**CITY OF SAINT PAUL**  
*Christopher B. Coleman, Mayor*

**DATE:** February 19, 2015

**SUBJECT:** *West Side Flats Master Plan and Development Guidelines* – Summary of Public Testimony and Committee Recommendations

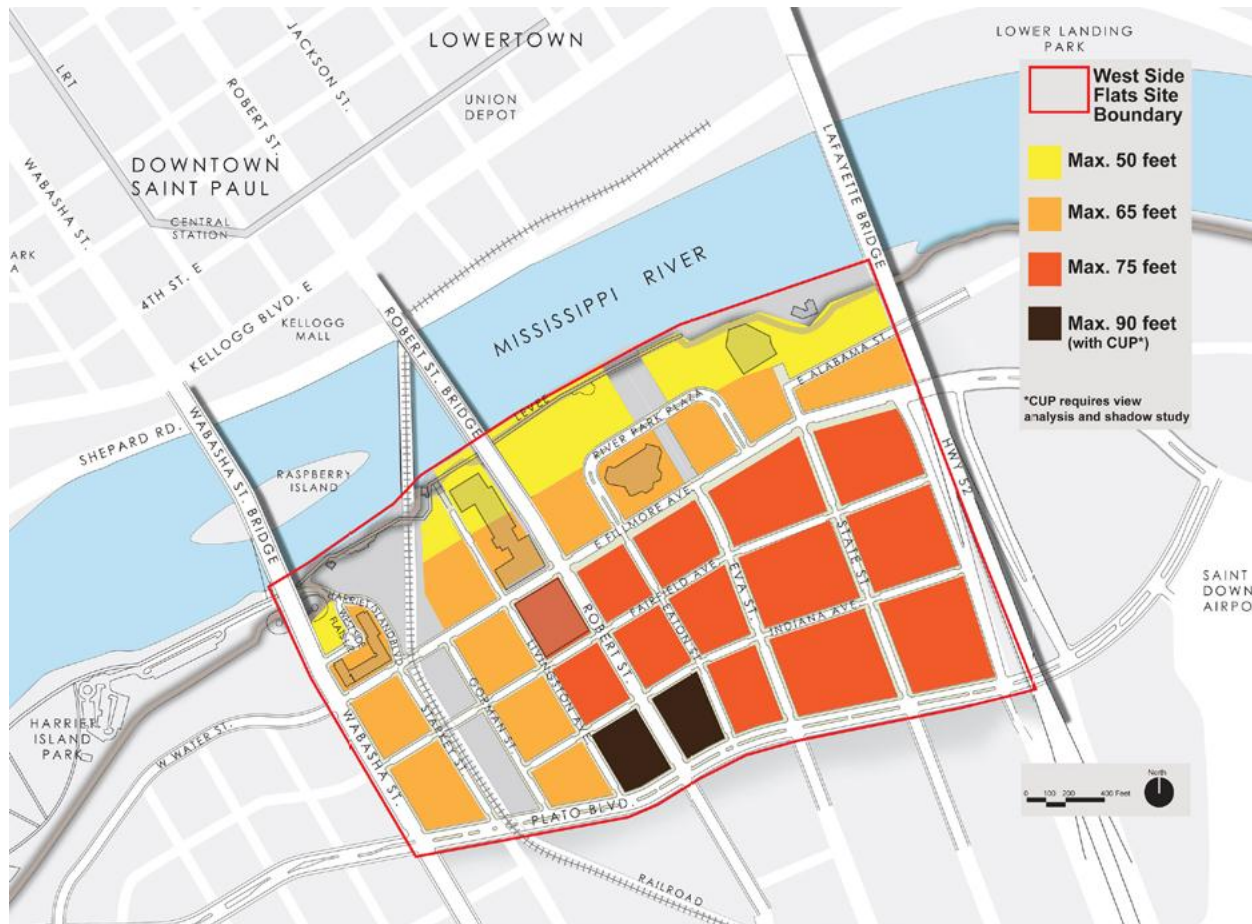
Most of the opposition to the draft Master Plan was presented by current or past employees of Rexam. They stated strong concern that the Rexam building is not shown on the Illustrative Plan on pg. 64, and that it is replaced with Eva Street Park and three new streets. Although the draft Master Plan states that the construction of new streets and parks throughout the planning area would be likely only in conjunction with private redevelopment; that parcels can be put to any legal use permitted under current zoning until such time as the City has the resources to build the recommended streets and parks; and that infrastructure changes in the area east of Robert and south of Fillmore are likely to occur in Phase IV (of IV, 20-30 years out), Rexam employees feel the future of their company is threatened. Most of the Rexam speakers asked that the Phase IV improvements be deleted from the Master Plan.

- There is a concern about the perception that the Master Plan is anti-business. While Commissioners don’t agree, the “baggage” of this perception is weighing down the Plan and derailing support for it.
- The overwhelming concern seems to be the depiction of streets and parks on the base maps and Illustrative Plan; there appears to be something particularly threatening about the plan graphics. Illustrations showing a future build-out condition can be very powerful, as has been shown in this case. A future vision of streets and parks where buildings exist today creates uncertainty about whether a business should invest in its building or inventory now or in the near future, knowing that a plan shows them gone in 20-30 years.

- p. 106 “...it is important to note that the construction of new streets and parks proposed in this Plan is likely only in conjunction with the redevelopment of private property, as the City is unlikely to have the financial resources to build public infrastructure without attendant private development. Until such time as the City has the resources to build the recommended new streets and parks, as part of a redevelopment project, parcels may be put to any legal use permitted under the current zoning classification, provided that the proposed use meets all applicable conditions and/or standards.”
- p. 108 “As redevelopment occurs, acquire right-of way for proposed streets in the Phase IV area...”
- p. 108 “As redevelopment occurs, acquire land for Eva Street Park.”

1. Remove the proposed streets and park east of Robert Street between Fillmore Avenue and Plato Boulevard from the Master Plan base map, which would remove them from all of the individual master plans (land use, urban design, acceptable building heights, street system, transit system, pedestrian and bike circulation, parks and open spaces, green infrastructure and public art) as well as the Illustrative Plan. The Illustrative Plan would show existing buildings and streets east of Robert between Fillmore and Plato, with a “bubble” explaining future strategies to pursue as redevelopment occurs in this area. As an example, a revised Street System Plan and Illustrative Plan are attached showing how the maps would look with these changes.
